Staff Report

Major Subdivision B

Case #: SUB-2018-07-00086

CYPRESS CROSSINGS SUBDIVISION

SITE PLAN–LOT LAYOUT
HAMMOND, LA

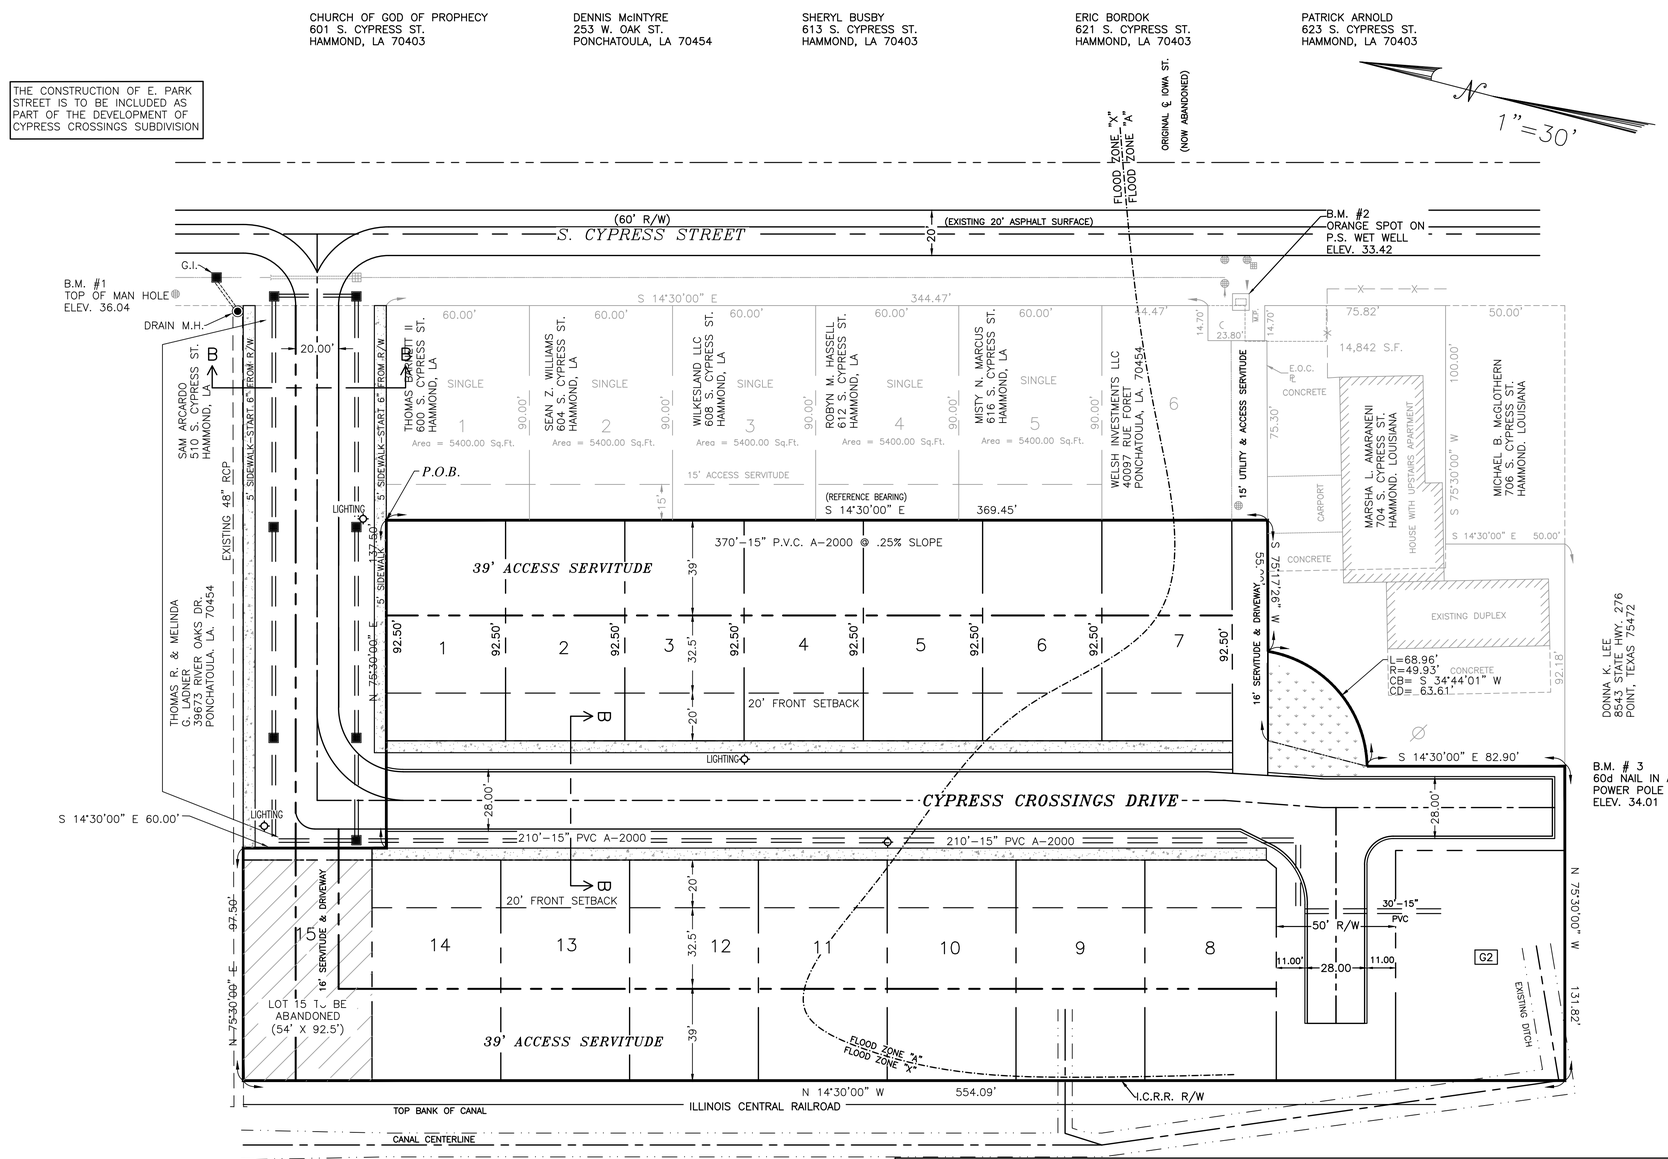
The Typical Curb and Gutter Street Section width ("26 ft" shown on sheet "5") and the back to back curb dimension called out on sheet "3" ("28 ft") are not consistent.

STREET & DRAINAGE PLAN

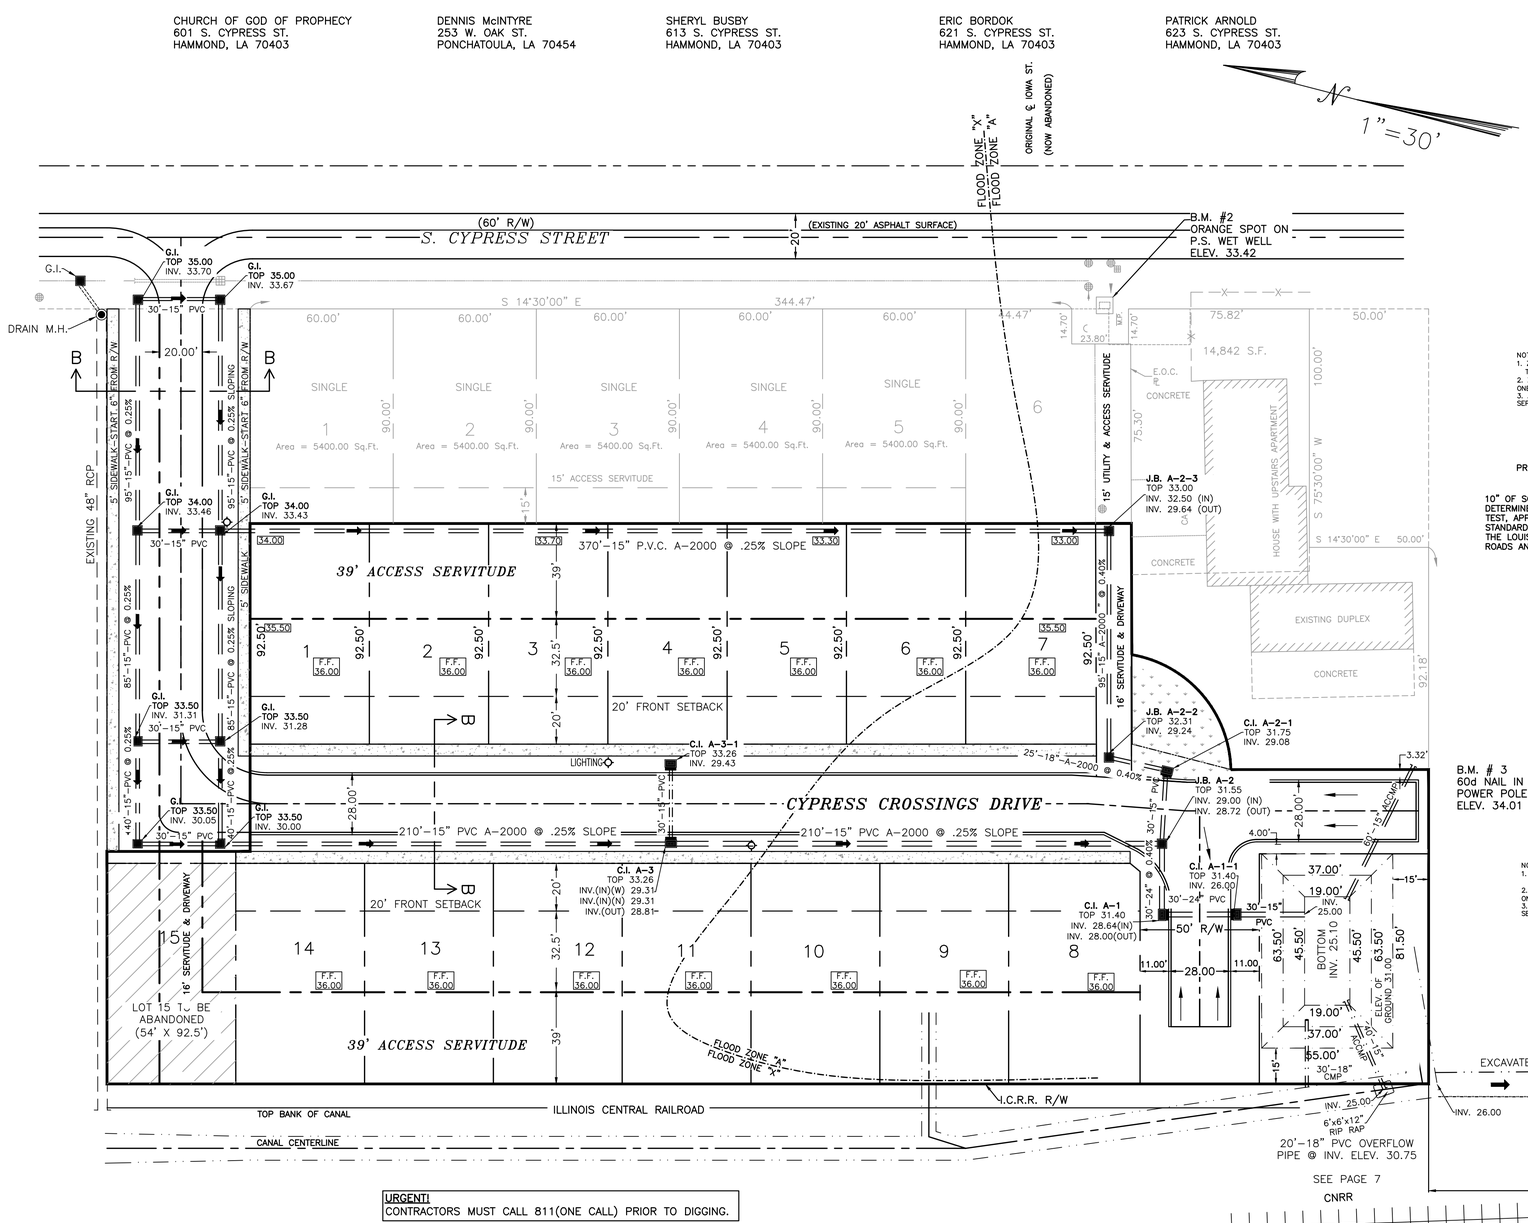
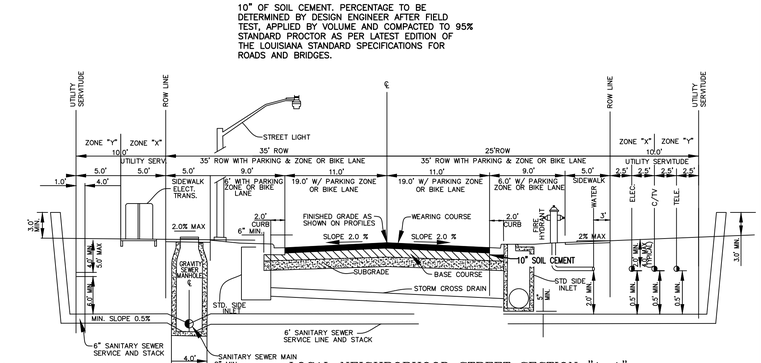
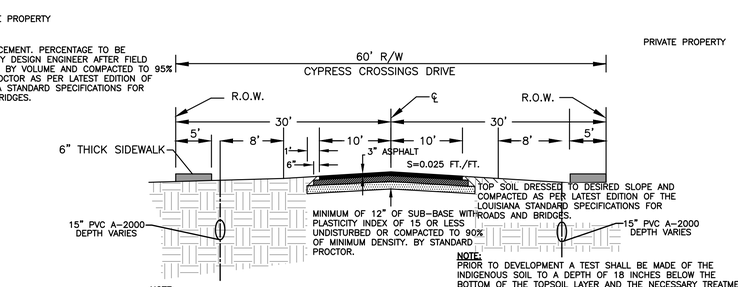
Assuming East Park Street is to be extended to the development, a typical street section should be shown and a note should be added indicating that it is to be built as a part of this development.
